DCE MEMORANDUM NO. 16-08
(FHWA Approved: 5/21/08)

SUBJECT: PLACEMENT OF DETECTABLE WARNINGS

PUBLIC SIDEWALK CURB RAMP

Sheet No. 6 of 6

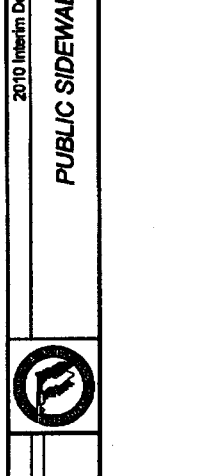
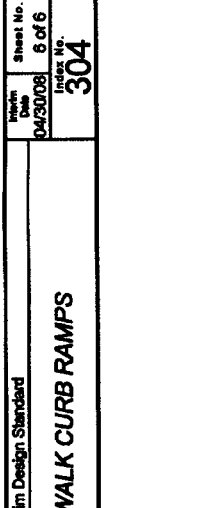
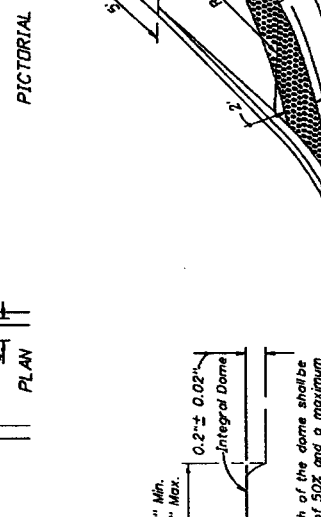
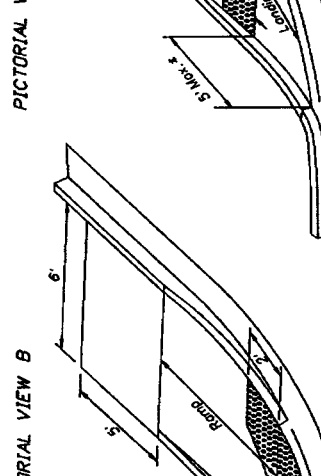
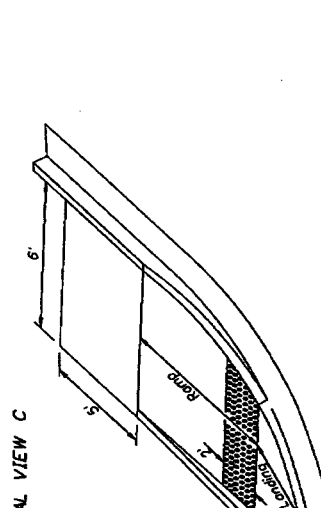
- When placed on curb ramps, landings and flush transitions perpendicular to the curb line: Rows of domes shall be aligned with the centerline of the ramp. See Pictorial View A on the attached Interim Design Standard Index 304, Sheet 6 of 6, dated **04/30/08**.

- When placed on landings and flush transitions at radius returns: Rows of domes are **not** required to be aligned with the centerline of the ramp. See Pictorial View B on the attached Interim Design Standard Index 304, Sheet 6 of 6, dated **04/30/08**.
- When placed on curb ramps at radius returns: Rows of domes shall be aligned with the centerline of the ramp. See Pictorial View C on the attached Interim Design Standard Index 304, Sheet 6 of 6, dated **04/30/08**.

Interim Index 304, Sheet 6 of 6, dated **04/30/08**, will not be referenced in contracts until the January 2009 letting. **For all projects let prior to January 2009, this memorandum serves as a blanket approval to process a \$0.00 contract change to allow the use of this Interim Index. A copy of this memorandum should be attached to the Work Order or Supplemental Agreement.**
